ATTACHMENT 2

PROPOSED CHANGE TO
TECHNICAL SPECIFICATION TABLE 4.3-1, NOTE 14

SALEM MOD/GL 83-28

AUTO/MANUAL REACTOR TRIP CIRCUIT TYPICAL TRAIN 3

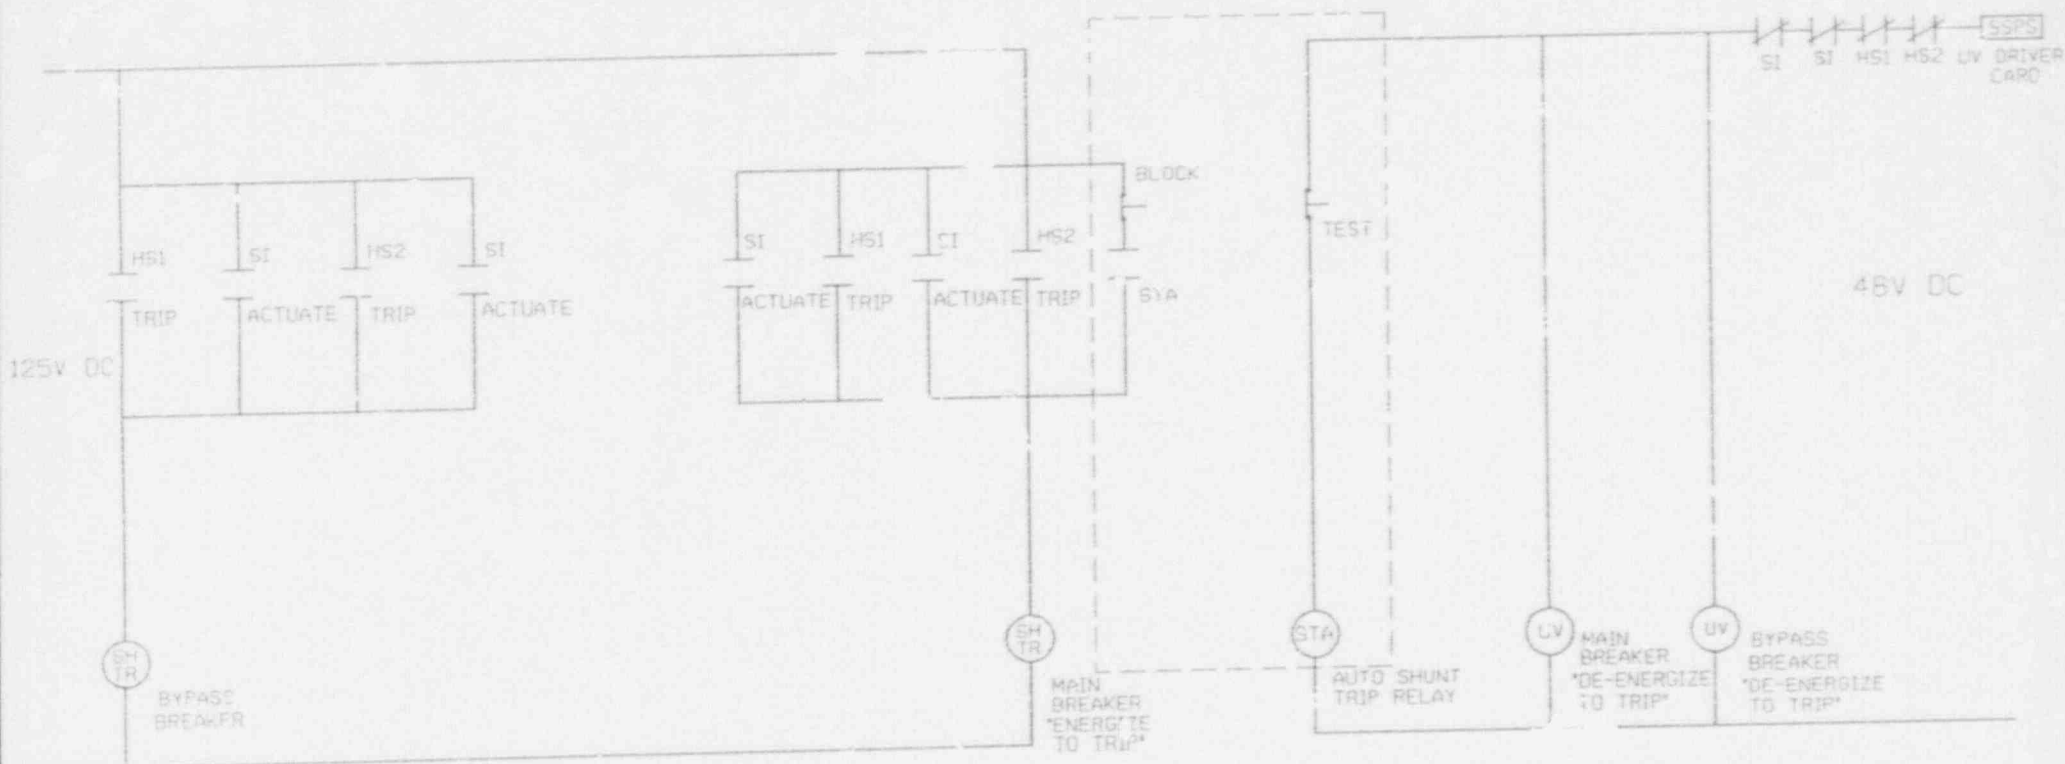
ALL HS1 CONTACTS OPERATE SIMULTANEOUSLY
ALL HS2 CONTACTS OPERATE SIMULTANEOUSLY
CONTACT *STA* CLOSES WHEN RELAY *STA* DE-ENERGIZES.
